402ND BATTALION IRAQI ARMY
HEADQUARTERS BARRACKS
AL HILLAH, IRAQ

SIGIR PA-06-077
JANUARY 29, 2007

SUBJECT: Report on Project Assessment of the 402nd Battalion Iraqi Army Headquarters
Barracks, Al Hillah, Iraq (Report Number SIGIR-PA-06-077)

Site Photo 3. Interior of one of the two barracks

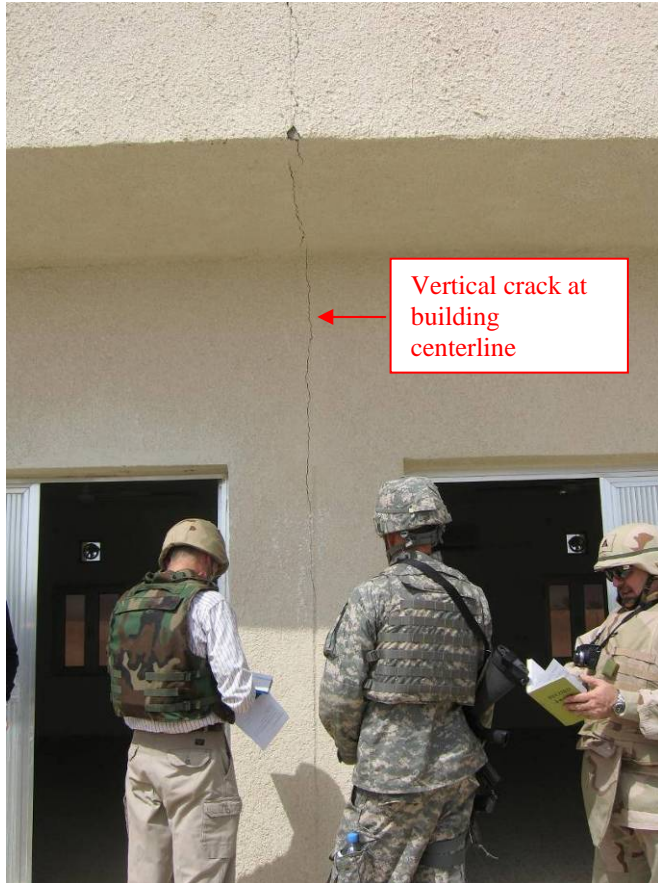
Although the interior appeared satisfactory, the two entry/exit aluminum doors in the barracks sleeping quarters did not appear to be "good quality," especially for the high traffic expected with a 75-man barracks. Site Photos 1 and 2 provide closer views of one of the aluminum doors and associated hardware. In addition, the doors did not have sweeps. Noticeable gaps were present between the thresholds and bottom of the doors as seen in the door shown in Site Photo 3.

Site Photo 5. Vertical crack in front side of classroom building exterior

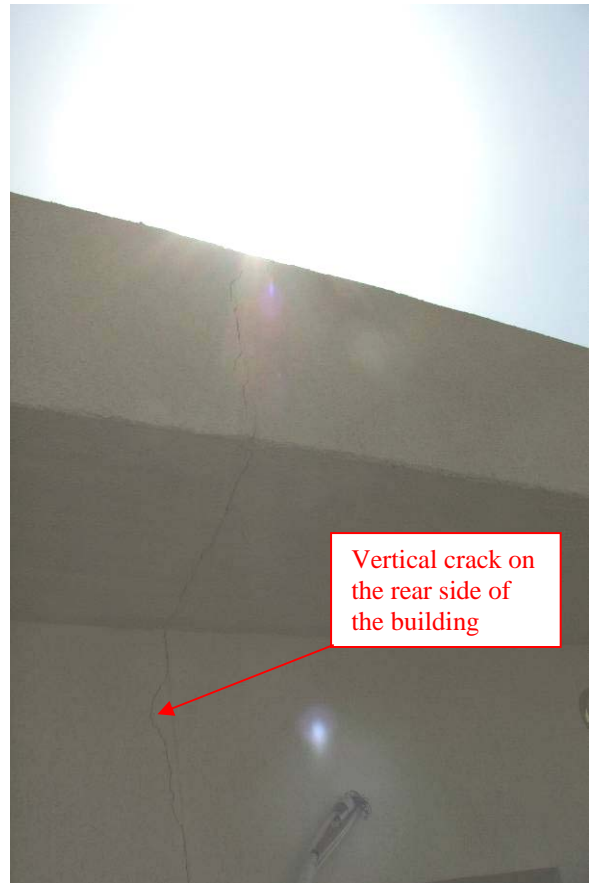
The design included two, two-ton HVAC units in each classroom augmented with a ceiling fan, and two wall exhaust fans, which we verified as installed. Overall, the building appeared satisfactory, except we did observe a noticeable crack in the exterior near the center of the building. The crack ran on both sides of the building, beginning at the sidewalk and continuing vertically in the wall and along the soffit and parapet as shown in Site Photos 5 and 6. The structural design for the building shows in the center of the building, a 480 mm masonry wall consisting of two, side by side masonry wall sections, each 240 mm thick. The design also shows the dual masonry walls supporting two adjoining bond beams, each 250mm thick. The design does not show any tying mechanism between the dual masonry walls or connecting reinforcing steel or dowels in the two concrete beams. Based on this design and the presence of the vertical crack along the building centerline, it appears there should be an expansion joint in the center of the building to allow for the differential movement of each side of the building.

Figure 1. Design detail for covered parking (sunshade)

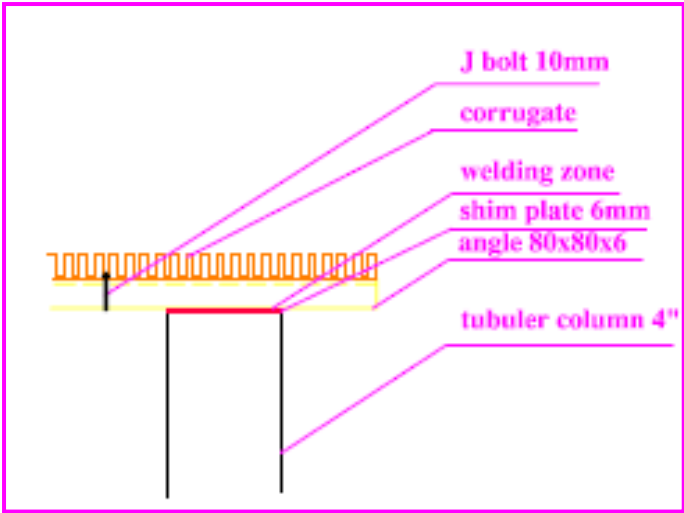
The design detail for the structural frame supporting the corrugated roof sheeting (Figure 1) showed an 80 x 80 x 6 angle supporting the roof sheeting. No units were provided for

the angle, although it is assumed the dimensions are in millimeters. Figure 1 also shows the angle welded to a shim plate at the top of the column. There were no details provided on the type or size of weld or the type and thickness of the corrugated roof sheeting. The design also did not show any lateral cross bracing perpendicular to the angle support shown in Figure 1.

Site Photo 13. Typical column support for covered parking (sunshade)

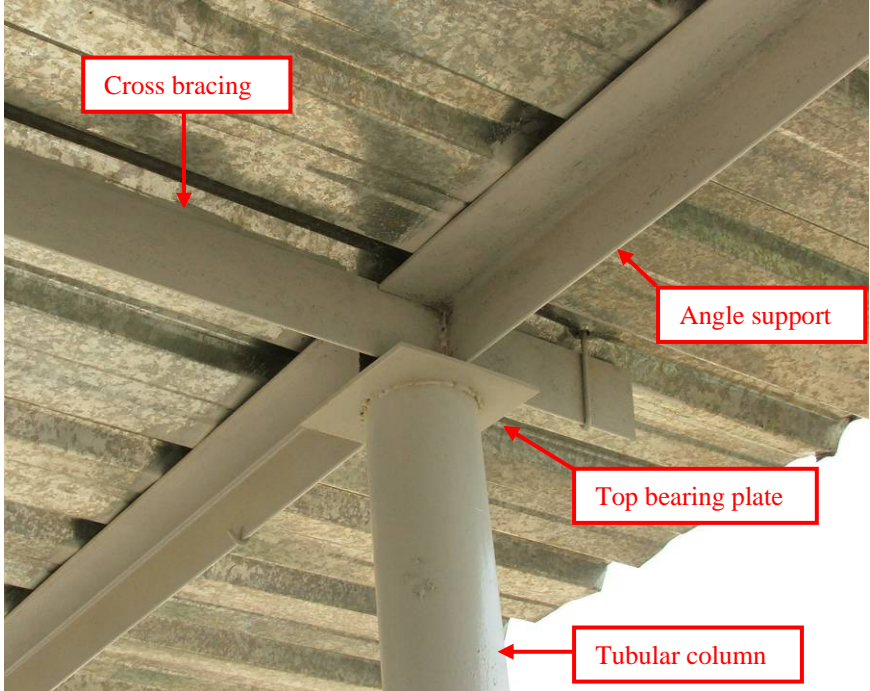
Site Photo 13 shows the actual welded angle connections at the bearing plate (i.e., shim plate) at the top of each tubular column. Also shown is the lateral cross bracing. The roof sheeting material appeared to be a thin gage sheet metal, connected to the frame with J-bolts as depicted in Figure 1.
